HOWARD UNIVERSITY

OFFICE OF THE SENIOR VICE PRESIDENT
AND EXECUTIVE DEAN FOR HEALTH SCIENCES
RADIATION SAFETY OFFICE

**SUBJECT: AMEND LICENSE 08-00386-19
TO REMOVE RADIOACTIVE WASTE
STORAGE FACILITY COLLEGE
STREET 510 – ADDITIONAL
INFORMATION REQUESTED 6/18/12**

Close-Out Survey Report for Radioactive Waste Storage Facility 510 College Street

Figure 1 Diagram of 510 College Street

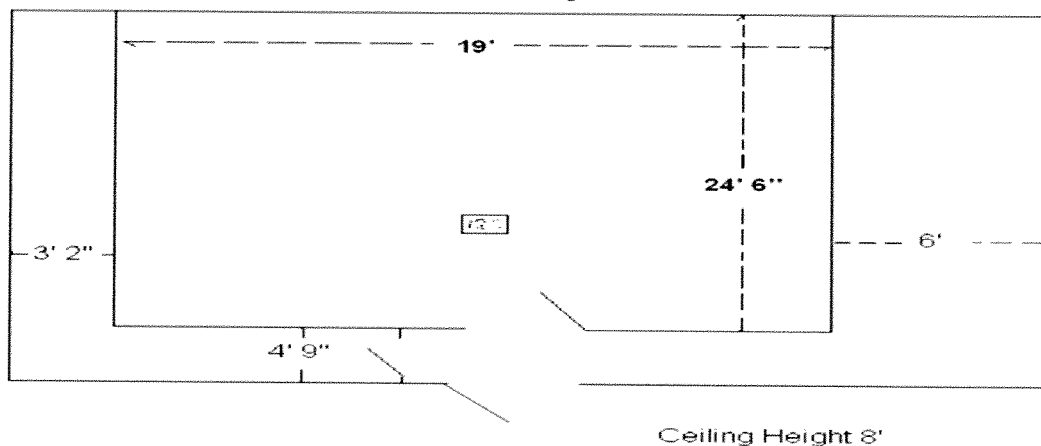
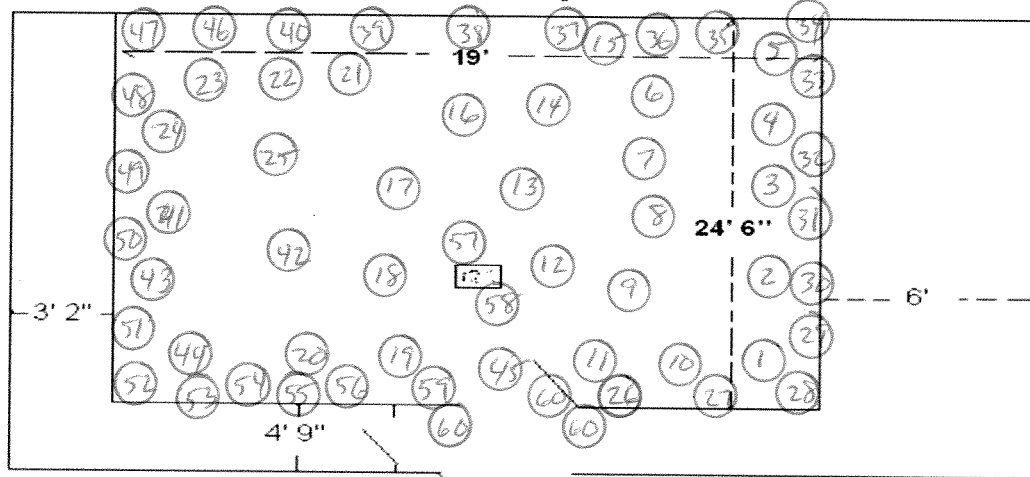
- a. Please explain what the actual dimensions of the room are, and explain what the dimensions in Figure 1 refer to, if they are not the dimensions of the waste storage area.

- b. Please use diagrams that show the dimensions of the room more accurately, with the location of survey points.

We re-measured the room area inside the waste facility. The actual dimension is about 24.5 ft. by 19 ft. (~465.5 ft. ²).

Please see attached

510 College Street Close Out survey Points

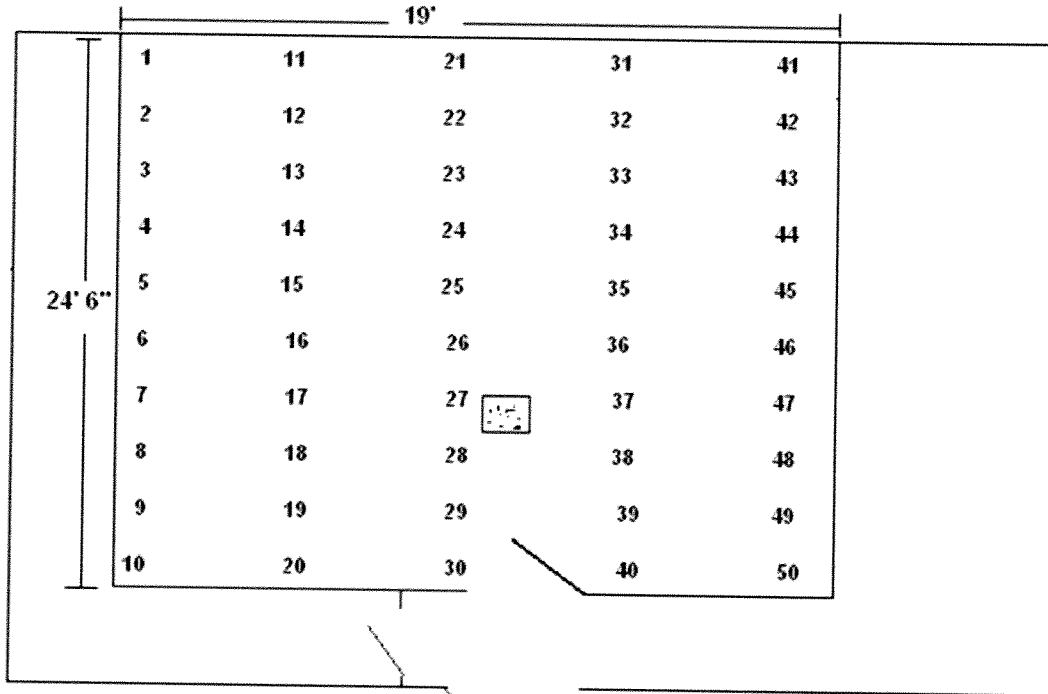
4. Plotting the results of your surveys on the diagrams provided show elevated total residual CPM in the back right-side corner of the diagram; and removable counts above background in the same area, as well as in the area near the table and door. Especially if residual activities were closer to the screening values, such plots are useful in identifying areas that may require additional attention. No response to this item is required at this time, because the removable contamination levels were well below the screening value.

Response not required at this time per your instructions.
